Refurbish Circuits Q2AH and Q5G between Louth Junction and Beamsville T.S.
Notification of Approval of Connection Proposal
CAA ID Number: 2005-EX244

ASSESSMENT SUMMARY

Refurbish Circuits Q2AH and Q5G between Louth Junction and Beamsville T.S. CAA ID Number: 2005-EX244

EXISTING LINE SECTIONS & ROADS

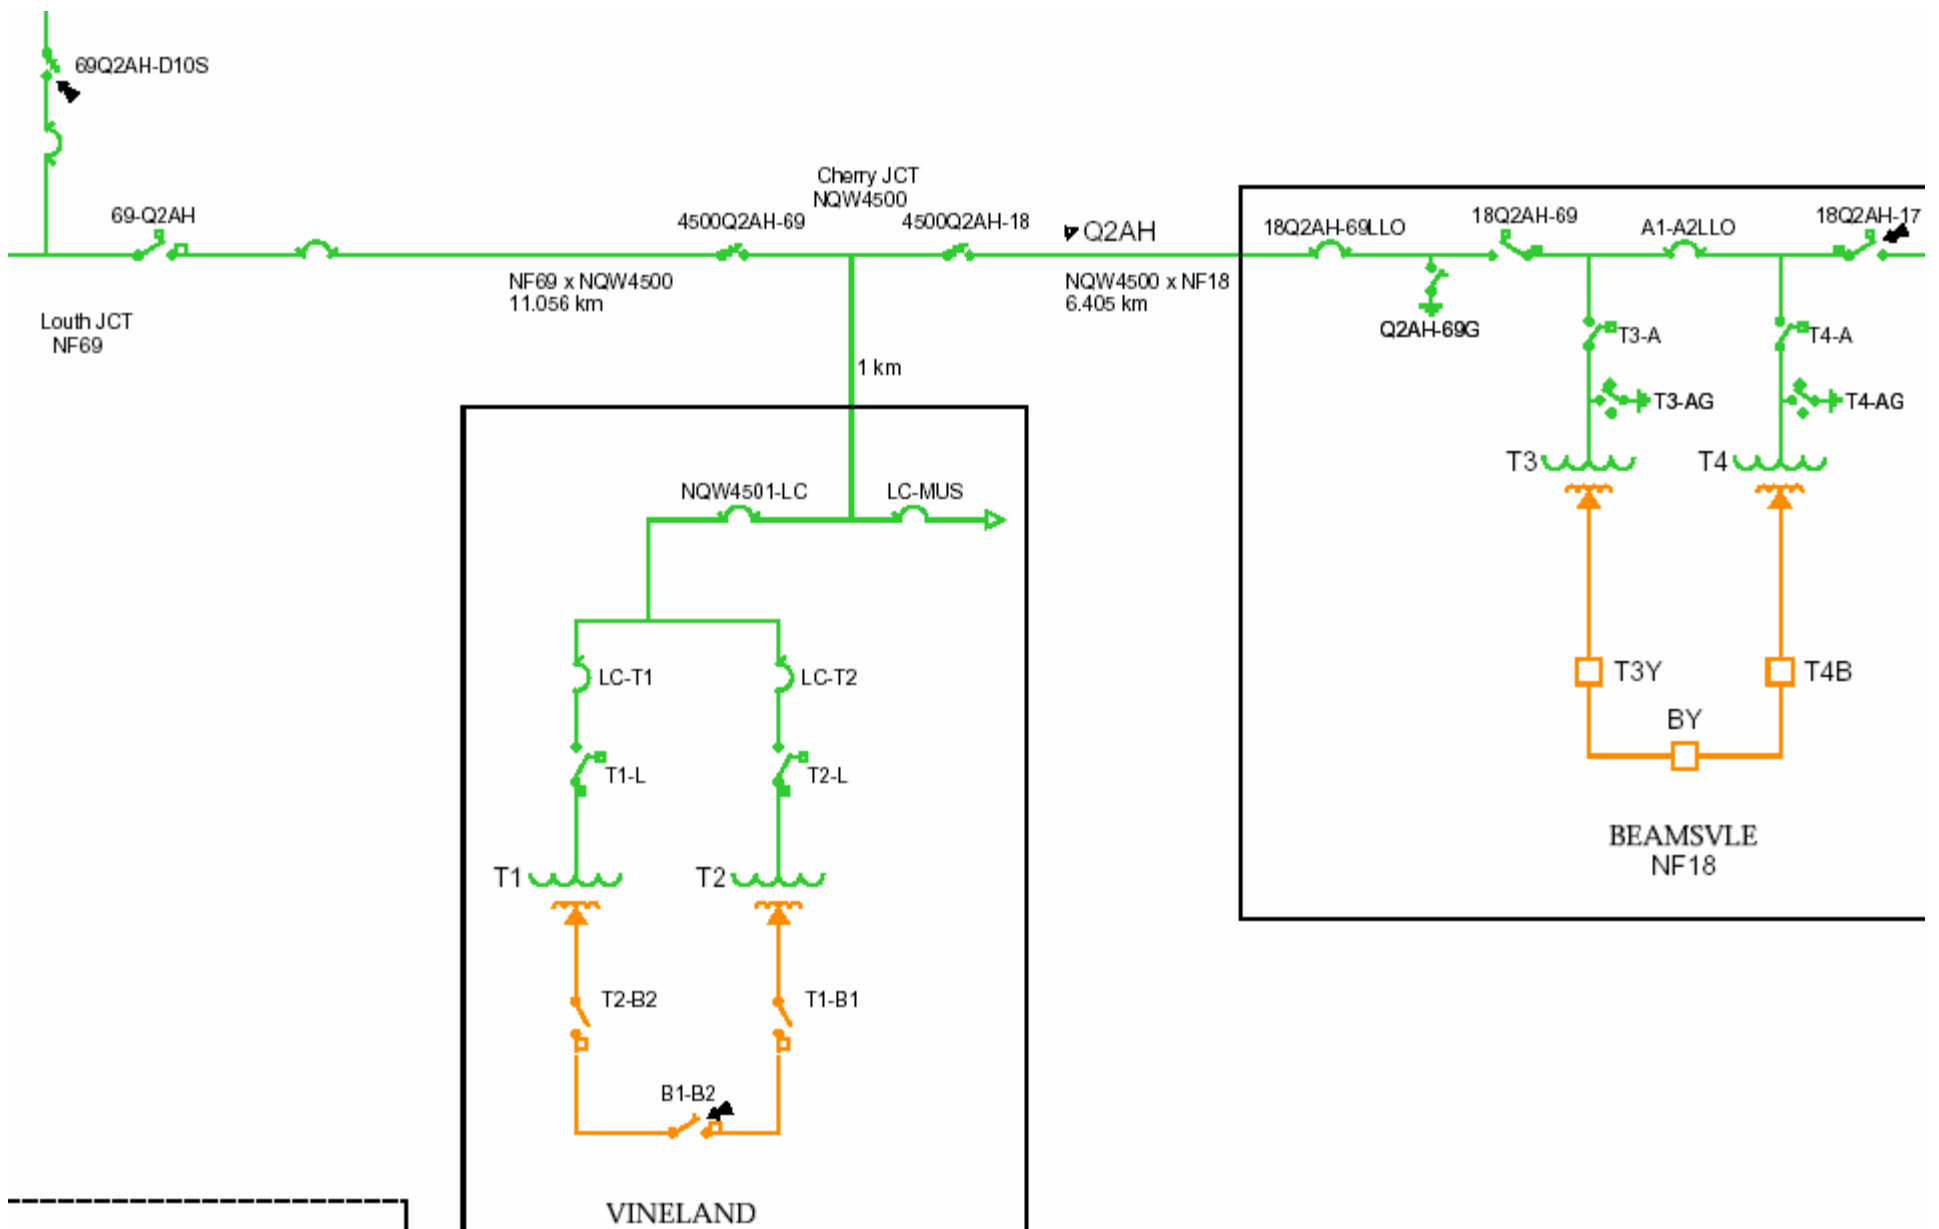
The new disconnect switches (4500 Q2AH-69 and 4500 Q2AH-18) have a rating of 1200 amps continuous which is equivalent or better than the existing switches. They exceed the current circuit loading requirements.

These replacements represent like-for-like exchanges and will not have any material adverse effect on the IESO-controlled grid.
